MILITARY SPECIFICATION

LOUDSPEAKERS, PERMANENT MAGNET, BIASTPROOF
AND SUBMERSIBLE, NAVY TYPE 4954b ()

This amendment forms a part of Military Specification
MIL-L-16225B(SHIPS), dated 12 January 1961.

FIGURE 2. Orientation in acoustical tests.

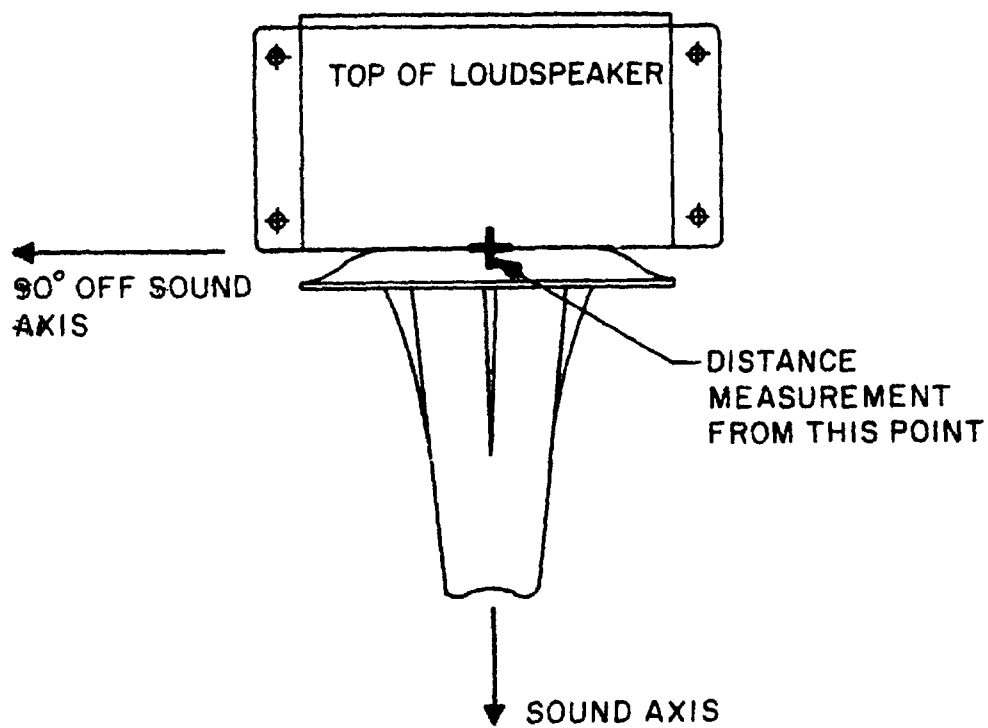
3.6.1, last sentence, delete and substitute: "The frequency response, when
tested 90° off the sound axis (see figure 2) shall be within the limits shown
in figure 1."

Following figure 1, add figure 2 as printed on page 2 of this amendment.
